**Union Branch Multiuse Pathway  
Bid #26014**

**Current Date: September 3, 2025**

Receipt of **Addendum No 1** to the City of Portland's **Bid #26014, Union Branch Multiuse Pathway**, is hereby acknowledged.

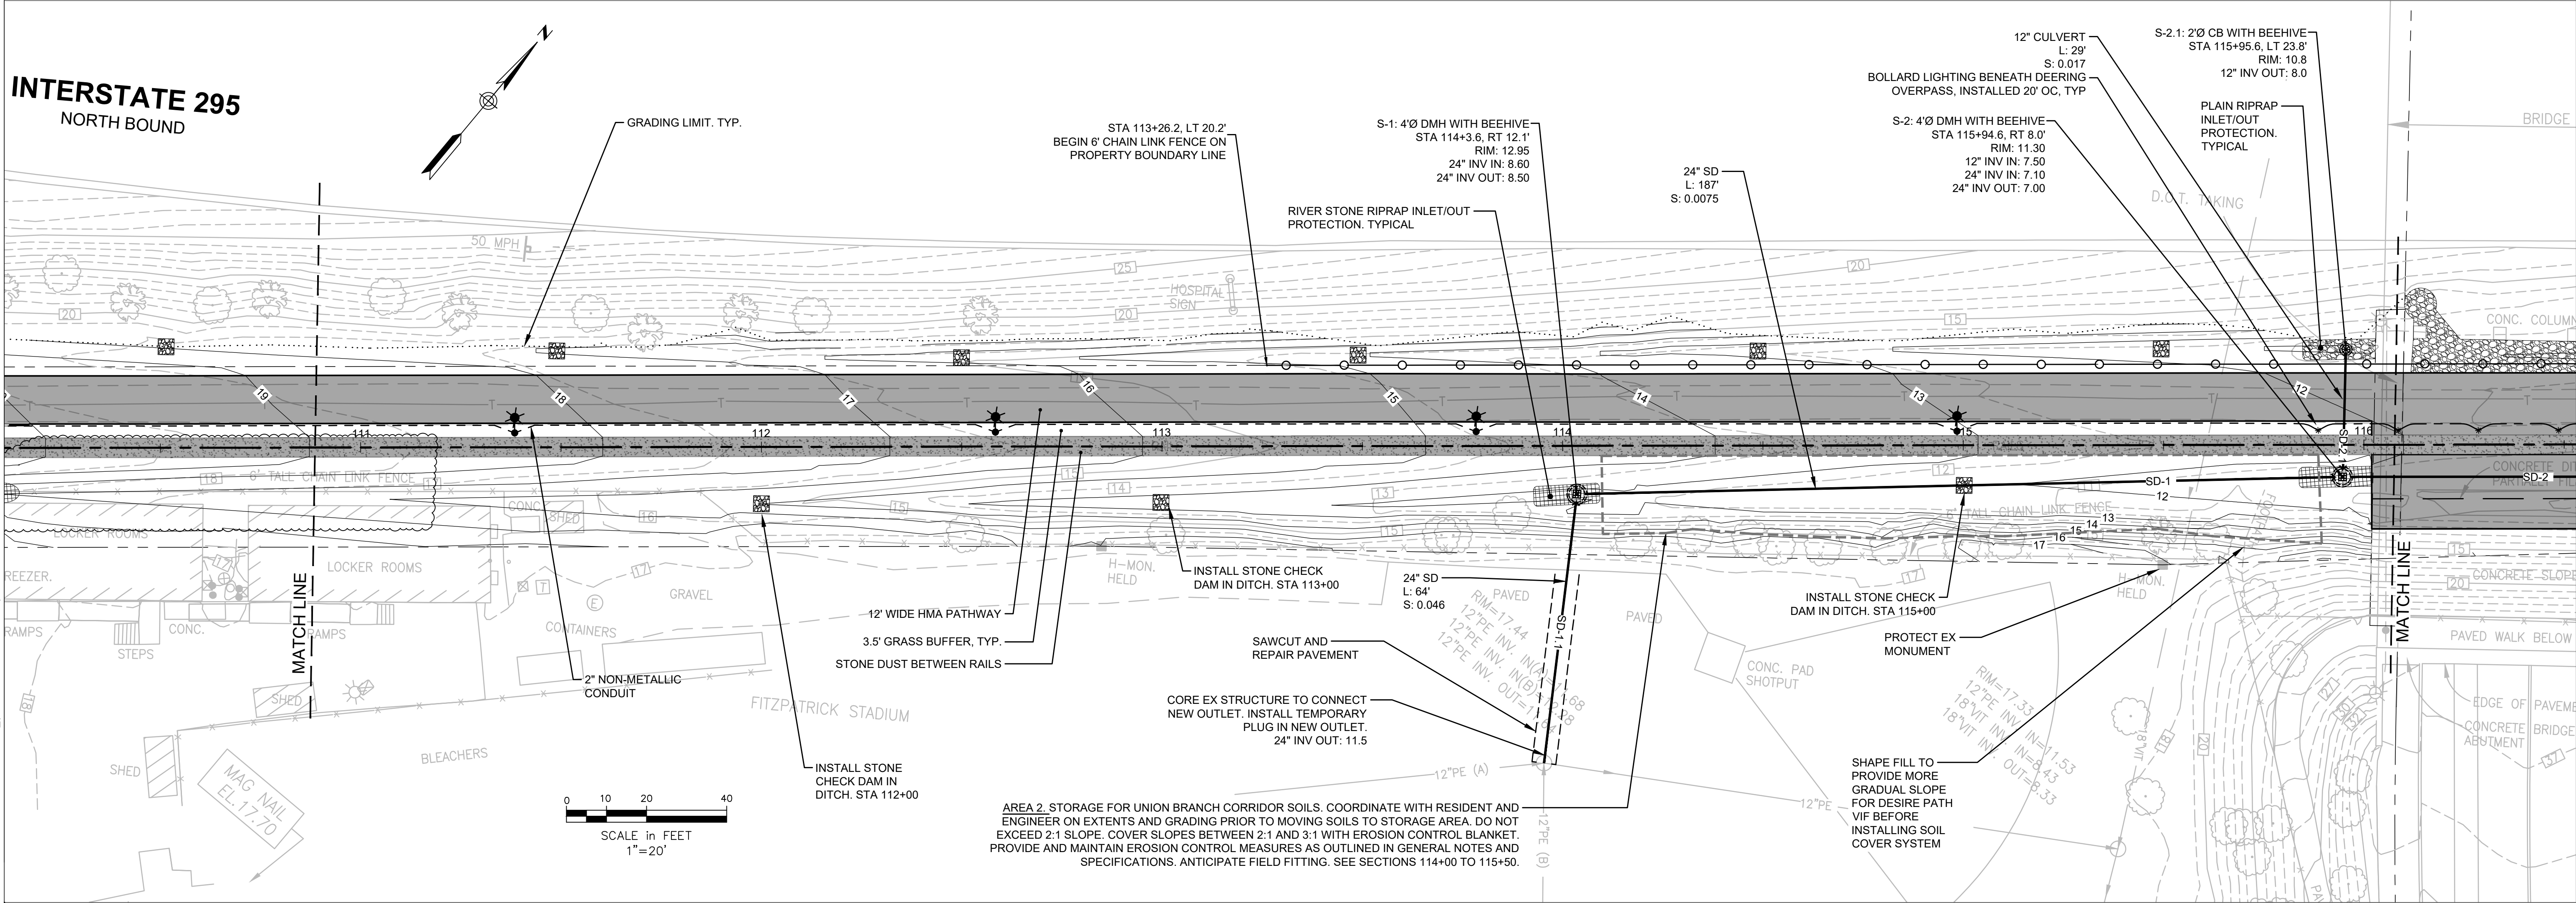
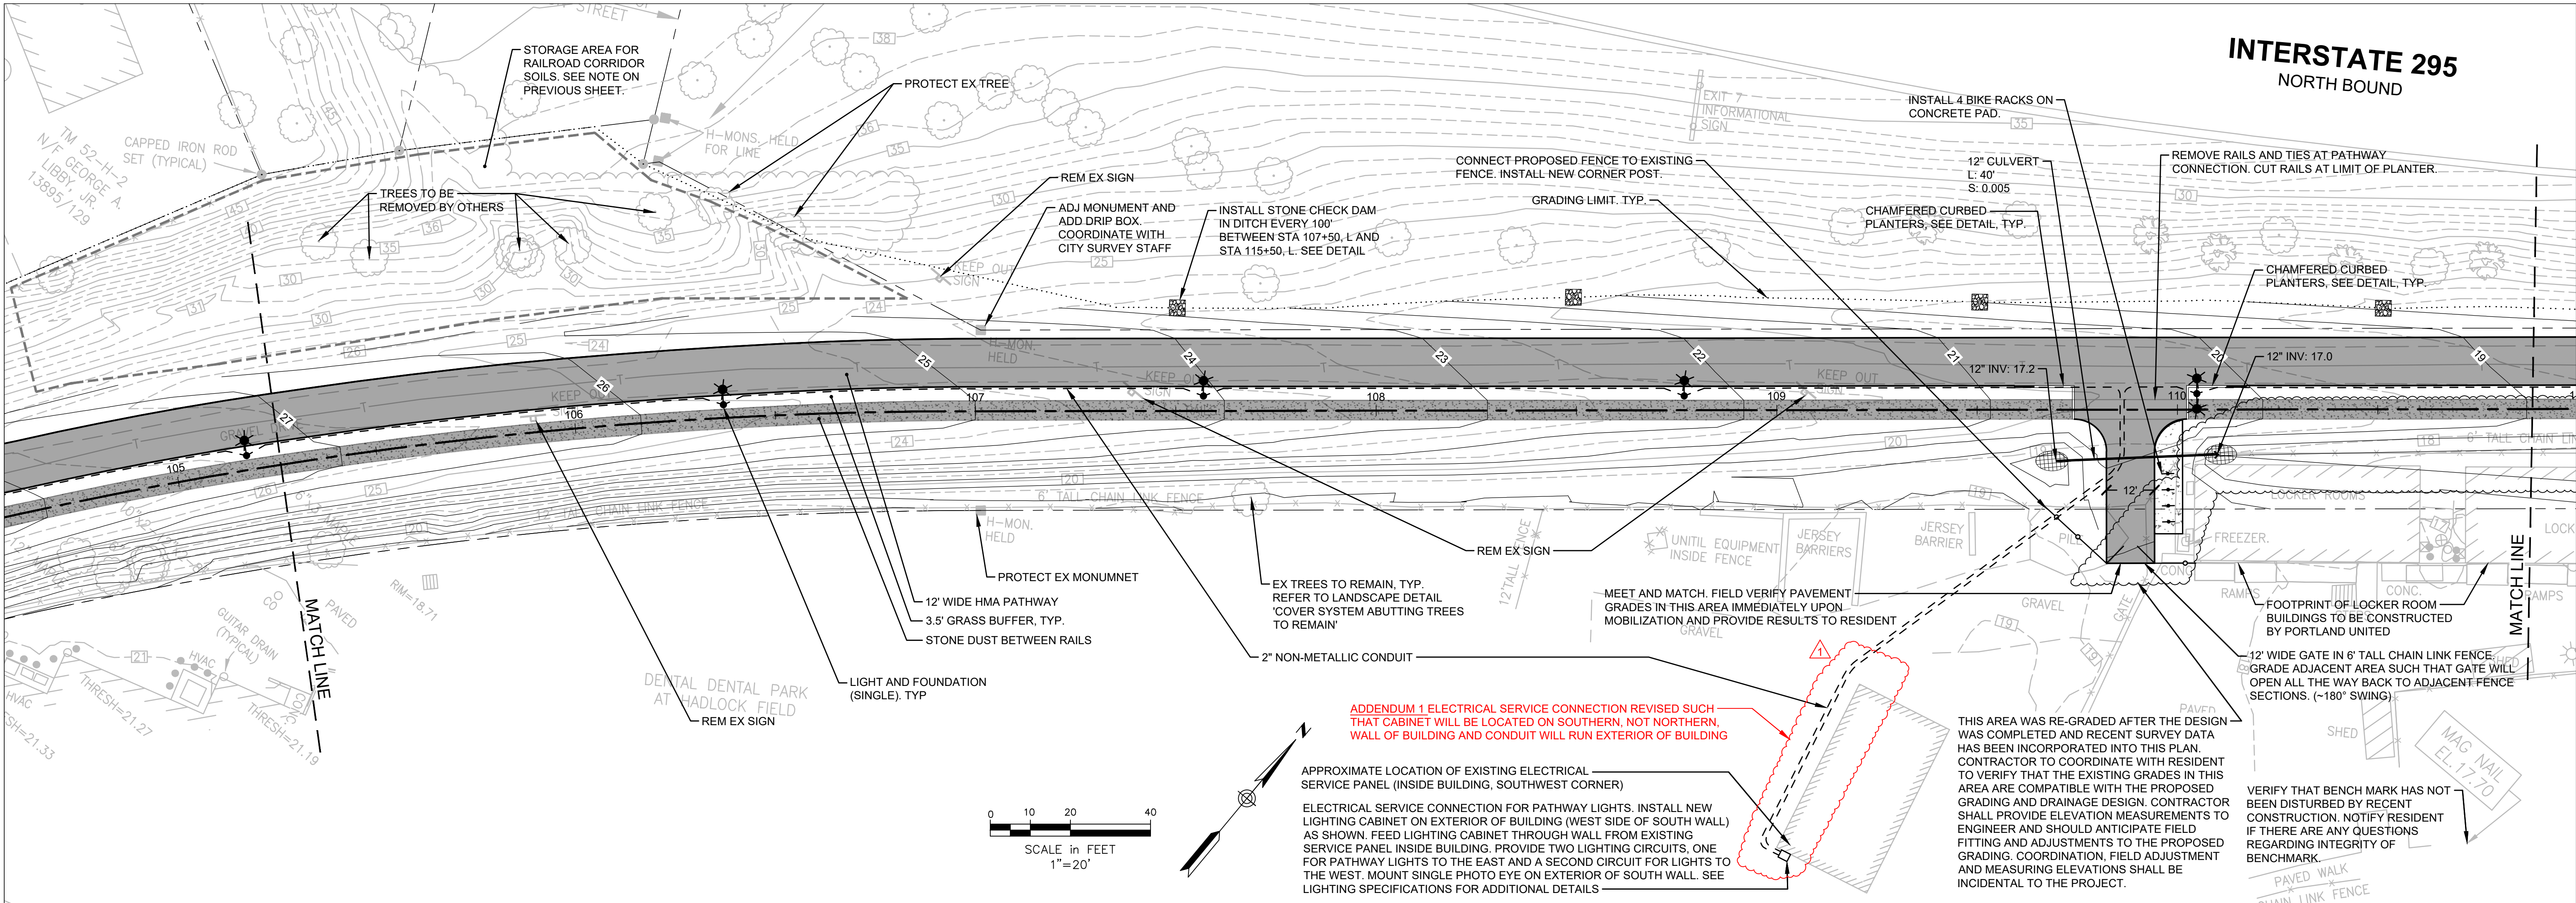
Addendum 1 includes additional stormdrain work along the east side of Deering Ave, between the proposed pathway and the entrance drive to Deering Oaks, as shown on the revised Sheet C-6 dated 2025-08-27 and as summarized below. A set of final plans with this change incorporated will be issued prior to construction.

- Drain Manhole S-4 will be shifted to the west as shown.
- Stormdrain and underdrain piping from the bioretention areas will be realigned to drain to Manhole S-4.
- Additional 36" and 30" stormdrain running parallel to Deering Avenue have been added as shown.
- Two (2) drain manholes (S-5 8' diameter and S-6 5' diameter) have been added
- Four (4) test pits have been added to provide information on existing gas and sewer utilities.
- A revised bid form has been provided with updated quantities. The revised bid form includes two new items:
  - 603.181 30 INCH DIAMETER STORM DRAIN PIPE (ALL DEPTHS)
  - 604.132 5' DIAMETER MANHOLE
- Special Provisions 603 and 604 have been revised to include the two new items above.

Addendum 1 includes adjustments to the lighting service installation at Hadlock Field as shown on the revised Sheet C-2 dated 2025-08-27 and as summarized below.

- The proposed lighting service cabinet will be located on the south side of the metal building identified on Sheet C-2, near the existing service. Proposed underground lighting conduit has been extended to this location.
- The Special Provision 626 has been revised to incorporate this change.
- The quantity for pay item 626.22 - NON-METALLIC CONDUIT (2") has been increased from 3800 LF to 3910 LF.
